STAFF REPORT: 11/16/2022 REGULAR MEETING

APPLICATION NUMBER: 22-8100

ADDRESS: 1517 ATKINSON

SCOPE: INSTALL VINYL AND GLASS BLOCK WINDOWS (WORK COMPLETED WITHOUT APPROVAL)

Four windows (three facing south and one within the recessed porch area) replaced in 2018. October 2022 photo by staff.

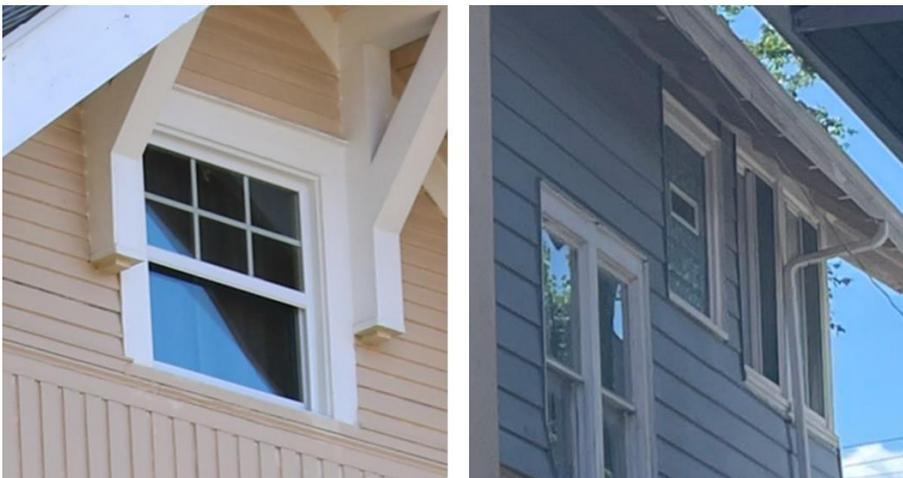
It is not known if the windows replaced in 2018 were original or historic. Nonetheless, the new windows are not appropriate. Secretary of the Interior's Standards for Rehabilitation, namely Standard #6, directs that "Where the severity of deterioration requires replacement of a distinctive feature, the new feature shall match the old in design, color, texture, and other visual qualities and, where possible, materials. Replacement of missing features shall be substantiated by documentary, physical, or pictorial evidence."

Appropriate new windows would match or closely approximate the dimensional qualities of historic windows found elsewhere on the house. Particularly inappropriate are the attic window, where a prominent vertical mullion has been eliminated, and the second floor west elevation window, where glass blocks have been added.

Staff recommends that the Commission issue a Denial of the proposed work as it does not meet the Secretary of the Interior's Standards for Rehabilitation, in particular:
